## SERVICE BULLETIN

**BULLETIN NO:** SBUS000128-25

**TITLE:** Replacement of Hardware on HR1500 Ford F250

**PRODUCT SERIES / MODEL:** 2023-2025 Ford F250/F350 Pickup Trucks with R1500C and HR1500D Series Hy-Rail® Guide Wheel Units Rear Mounting Kit (5067512) installed.00 Tamper

2017 F250/350 4X2 4X4 PICKUP [mm]  
**HARSCO RAIL**  
 5067512  
 1 of 1

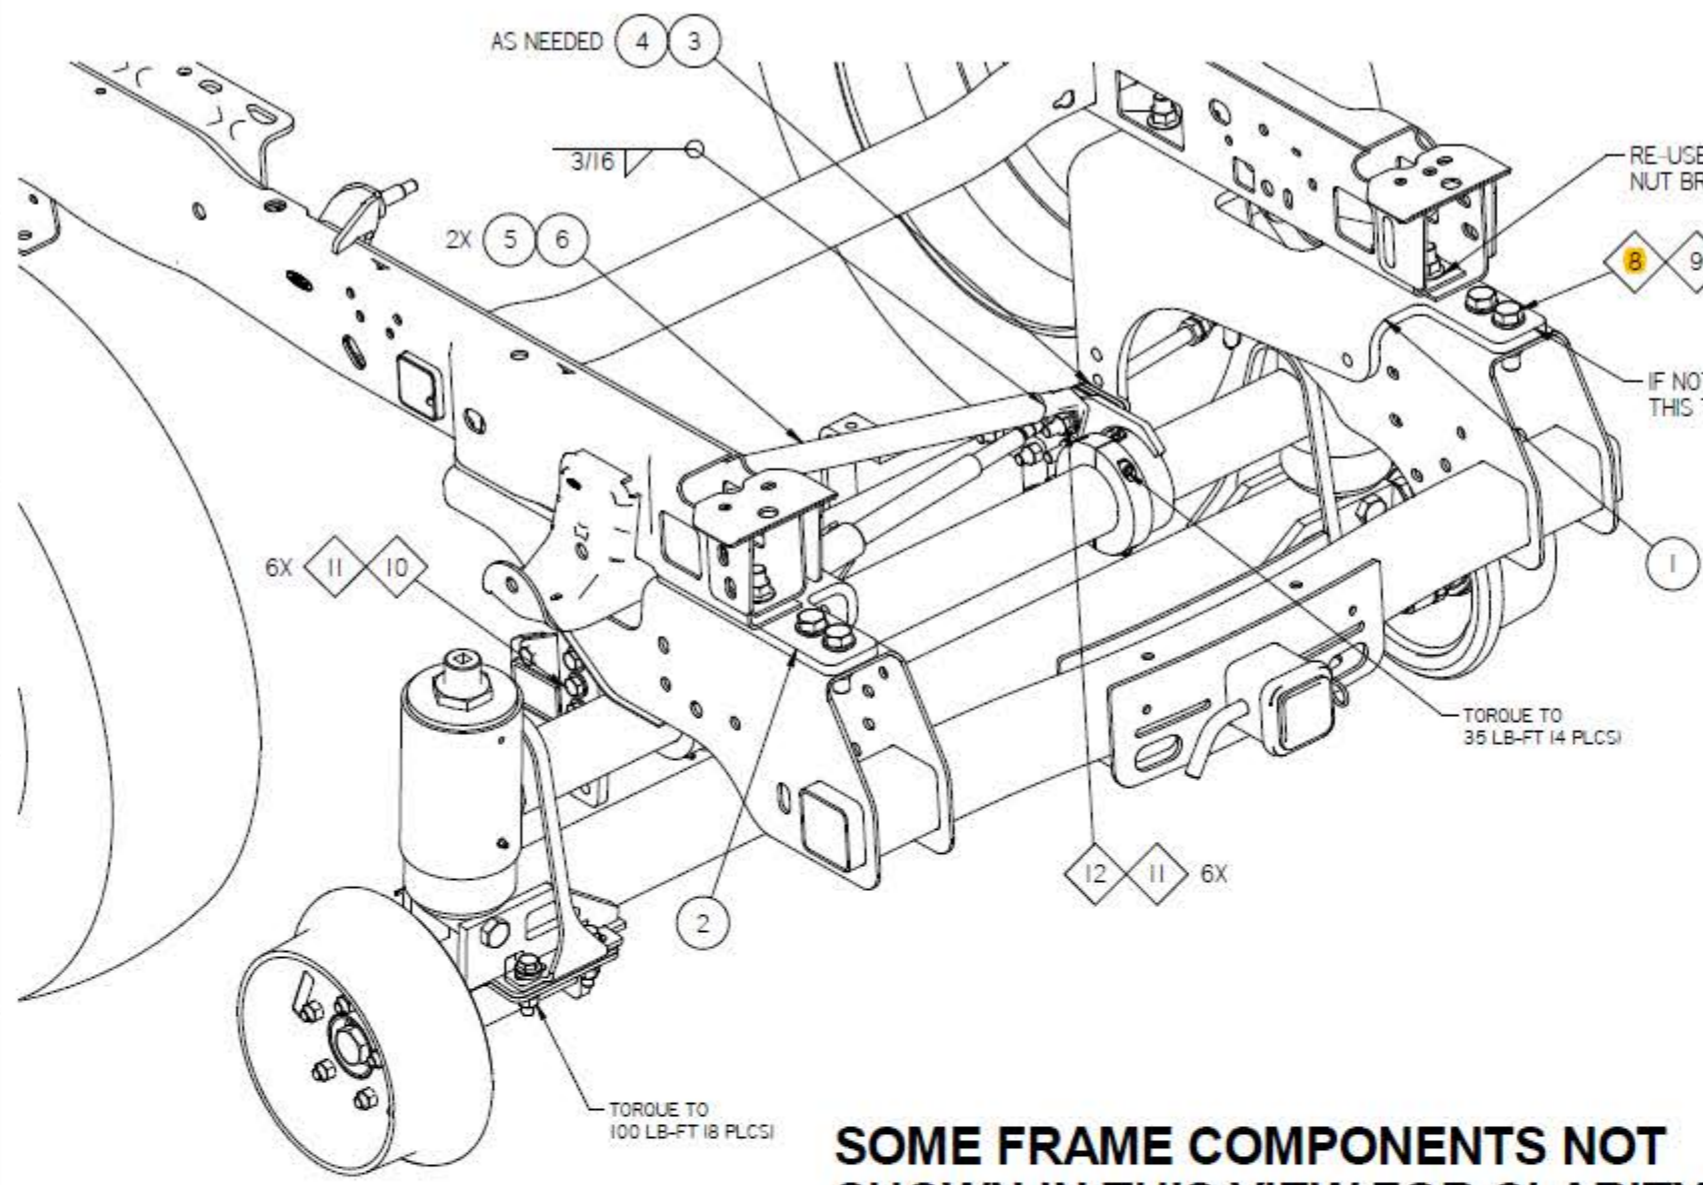
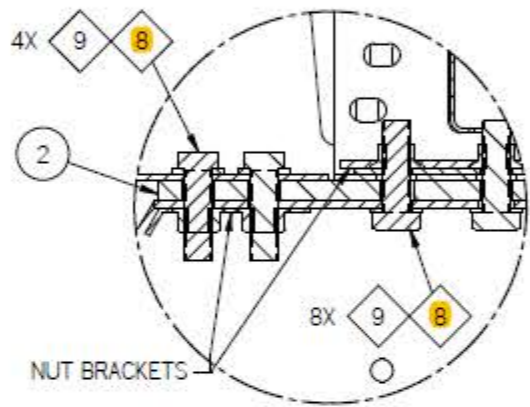
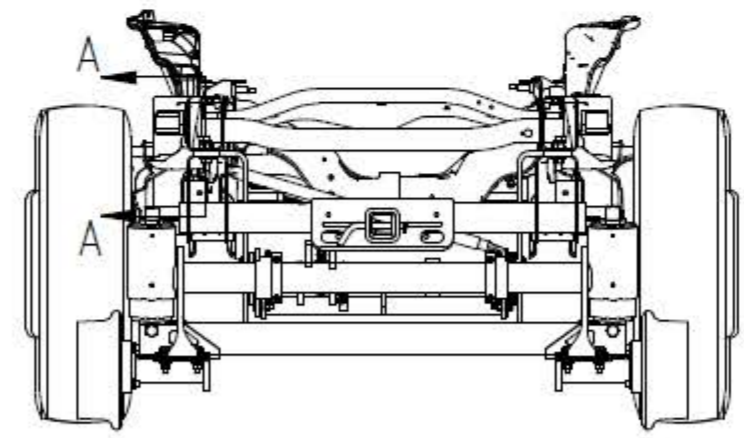
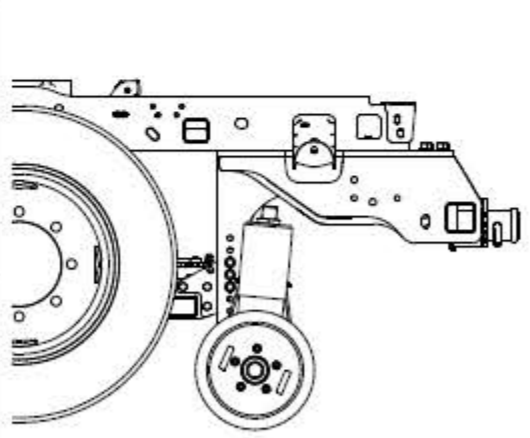
**SUMMARY:** The mounting bolts supplied with Rear Install kit (5067512) for 2023-2024 Ford Pickup trucks are too small (M18) for the threaded nuts (M20) being utilized in the truck for these model years. Verify install is correct and change bolts if necessary.

Ford changed their tow hitch mounting bolts and nuts from M18 to M20 in the 2023 Model Year. The Harsco Mounting Kits for these years were still supplied with the M18 bolts. If these M18 bolts were used and assembled with the Ford factory M20 nuts, the mounting would not be secured properly and could be at risk of derailment and damage.

5069322 (M18-2.5x60mm CL10.9) replaced with: 252566-89 (M20-2.5x60mm CL10.9)  
(SEE ATTACHED DRAWING)

1. Record serial numbers for front and rear units as well as any other identification information.
2. Inspect the truck frame, rail guide wheel unit, and rear mounting brackets for any signs of damage. If damage is found, replace or repair as needed.
3. Inspect the mounting fasteners to ensure they are proper size for the nuts and have been properly secured.
4. If the bolts are not correct, replace the bolts with new bolts P/N 252566-89 supplied or procured locally (M20-2.5 x 60mm Class 10.9 Hex Head Bolt).
5. Remove 1 bolt at a time and replace with correct bolt applying Blue Loctite and torque to 200 ft-lbs until all 8 bolts (w/o Tow Hitch) or all 12 bolts (with tow hitch) have been replaced.

APPLY BLUE LOCTITE TORQUE TO 200 FT-LBS
